To: Chapel Hill Town Council  
From: Scott Radway, AICP  
Date: 3-20-2019  
Subject: Christ Community Church – Concept Plan Thoughts Based upon CDC Review

101-111 ERWIN ROAD MIXED USE

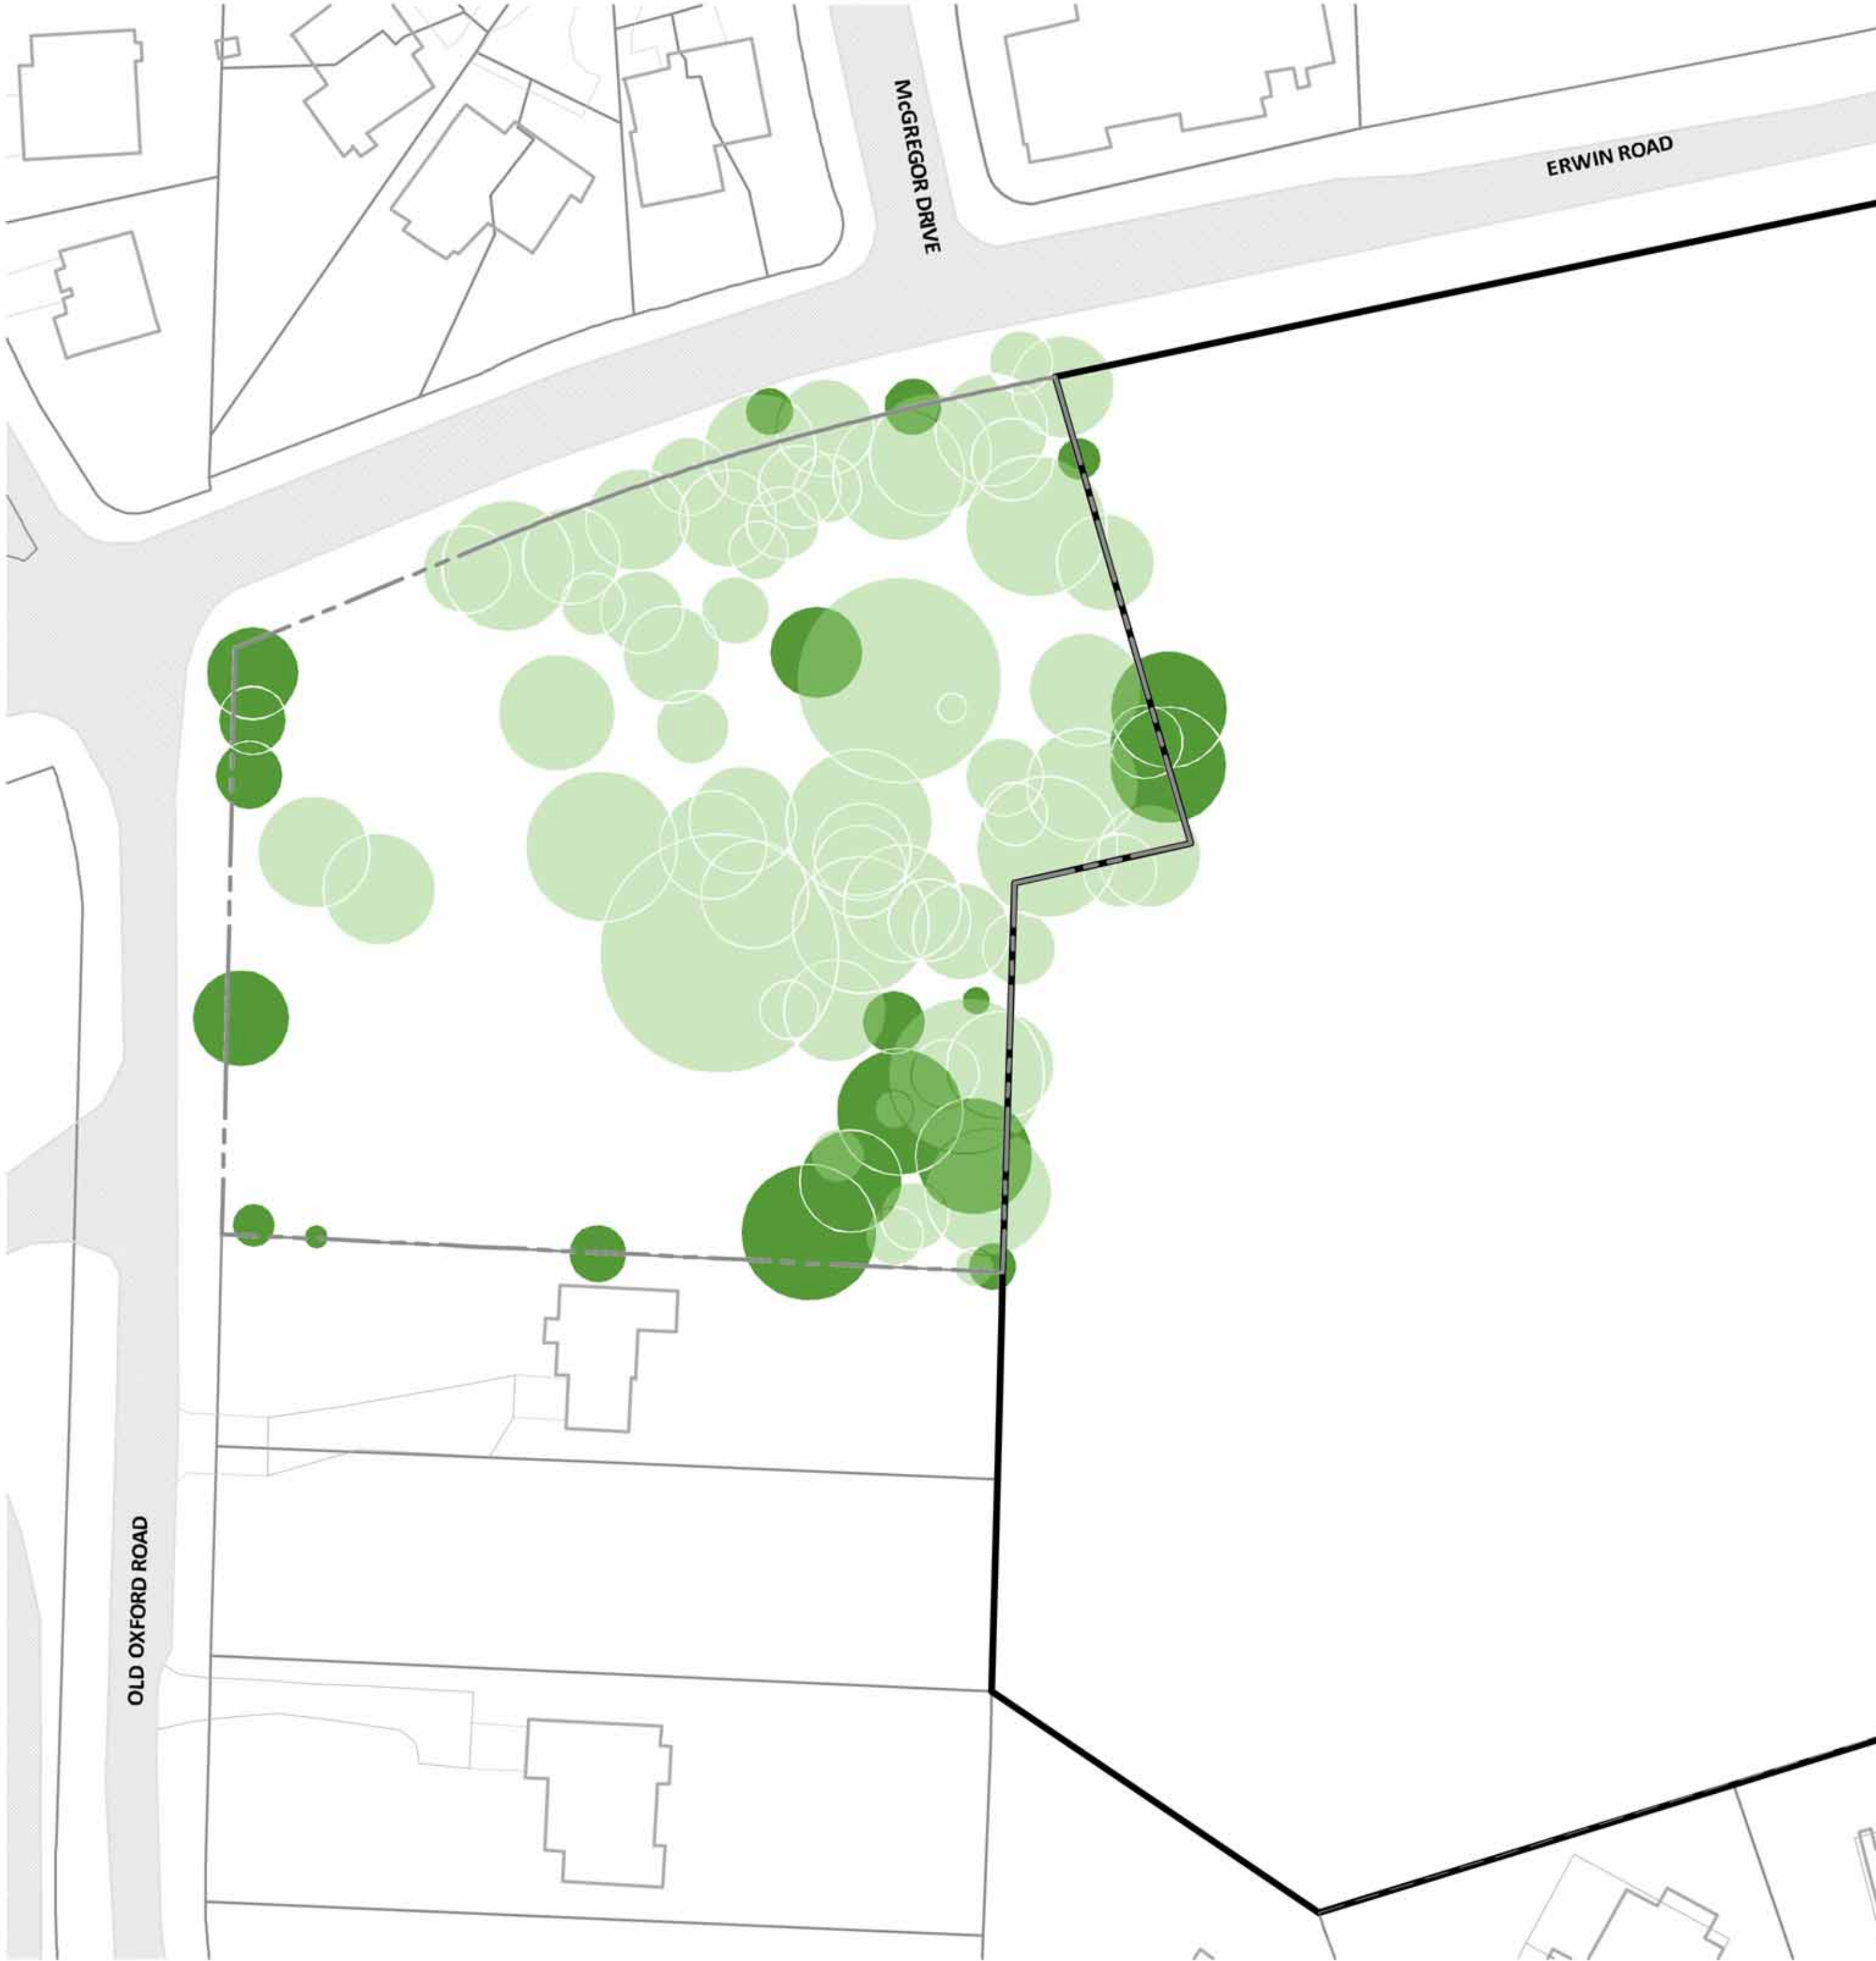
- a. This drawing shows the extensive existing vegetation.
- b. This should inform the design in some fashion
- c. Stormwater Flow and Discharge to adjoining property was not shown by applicant

- a. Development program – Two Buildings? Is that because there is a budget difficulty now?
- b. Parking Needed – Phase 1, Phase 2 – Plan states 123, shows only 106. Only 103 if connection to Summit property is provided.
- c. Why is the playground area located closest to the busiest street?

- a. To construct the applicant's plan the site has to be clear cut with a few perimeter trees remaining.
- b. Primary access from Old Oxford - with Almost all interior parking lot traffic is directed past one adjoining single family home where at present there is no existing vegetation buffer?
- c. Alignment with Kirkwood Entrance ?

- a. Primary entrance from Erwin Road – full Erwin Road improvements
- b. Move First Phase Building with Worship Hall to North & save trees along Erwin Road where playground is proposed.
- c. This relocation puts building and playground in areas that are primarily cleared of trees right now.
- d. 93 parking spaces at 9' widths. Is this enough? Not according to applicant's comments at CDC. Is 2<sup>nd</sup> phase building and use ever possible?
- e. How does plan relate to adjoining Summit proposal? Not shown by applicant.

- a. This exhibit shows a continuous 50' plus tree buffer along Erwin Road with the exception of the location of the proposed Church building.
- b. The proposed Church building is about 35' from Erwin Road - The proposed Multi-Family buildings of Summit are about 135' from Erwin Road.

- c. The proposed Church building is about 45' in height relative to Erwin Road. The proposed Multi-Family buildings are about 35' in height relative to Erwin Road. [3 Floors of residential above primarily below grade parking.]

- d. Entrances #1 and #2 – Summit Property. – Based upon Summit discussions with NCDOT and the Town, when developed, Entrance #2 will become a full-service entrance for both the Residence Inn Hotel and the proposed Summit residential development. Entrance #1 would become a right-in / right-out entrance to improve the safety and flow of traffic near the Dobbins Drive-Erwin Road intersection.
- e. Entrances #3 and #4 – Christ Community Church – Summit has not been involved in discussions with NCDOT about the Church property, but it seems very reasonable for Entrance #3 to become a full-service entrance drive.

Location #4 might be suitable for a right-in / right-out drive. However, it does not align with the Kirkwood drive on the north side of Old Oxford which may cause a problem.
